Response to EIS – Waterloo OSD – SSD 10437, 10438, 10439, 10440 and 10441

Thank you for your correspondence dated 4 November 2020 seeking comment on the EIS for the Waterloo OSD. City staff have reviewed the EIS cumulatively and provide the following combined response to the five SSD applications.

Figure 2: Extract from solar access plans

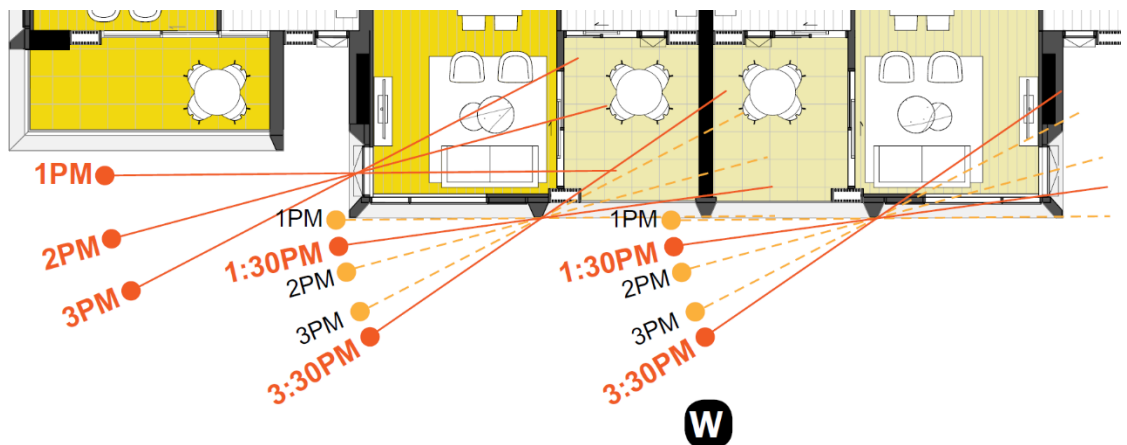
18. Solar access – Objective 4A-1 of the Apartment Design Guide (ADG) recommends, as a minimum, 70% of apartments be provided solar access to living rooms and balconies for at least two hours during midwinter. The application states that 57% of apartments achieve the design criteria. The City does not support the applicant’s justification for the non-compliance by including solar access after 3pm as this is not reflected in the design guidance or criteria and is of little thermal benefit due to the low altitude of the sun.

No information is provided to illustrate alternatives to achieve compliant solar access within the widely accepted criteria (9am to 3pm) such as staggering the floor plate to allow sun ingress from 1pm. Winter sunlight is generally discounted outside 9.00am-3.00pm as it is of little thermal benefit due to the low altitude of the sun. The more detailed solar information in the architectural design report demonstrates that even at 1.30pm, sunlight is too oblique to the facade and there is no benefit to extending the assessment criteria:

The tally incorrectly includes apartments as complying where only the living room glazing meets the criteria, rather than both living room glazing and balcony. This is not a correct interpretation of the ADG, which requires both to achieve a minimum of 2 hours of sunlight in order to be counted in the minimum 70% of apartments. This applies to both west facing apartments, and apartments at lower levels in the northeast corner of the plan, which are shaded by the southeast corner of Building 1. These apartments have been counted where only the balcony achieves the minimum amount of sunlight (loss of 3 apartments). The stated solar access tally is

incorrect and should be updated to reflect a correct interpretation of the ADG design criteria. It is likely to be well below the minimum when measured correctly.

Figure 3: Overlay of CSSI and SSD public domain plans

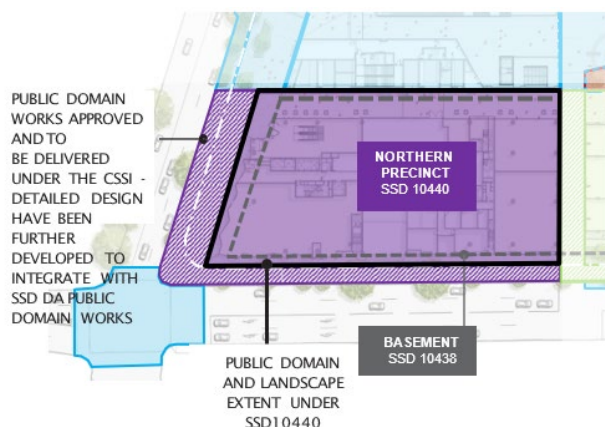
78. Public domain works - There is a discrepancy between the scope of works to be undertaken by the station development under CSSI and these SSDs. The CSSI documentation only shows half of Raglan St and Wellington St and no work to Botany Rd. The through site shared zone is included in the Metro Station development and the cycleway along Wellington isn't. It is strongly recommended that the Interface Agreement and the scope of public domain work is agreed prior to the detailed design SSDs being approved.

The excerpt below is from the Northern precinct landscape plans. It is incorrect as it should include the purple hatched area. These works are not included in the Metro station development works.
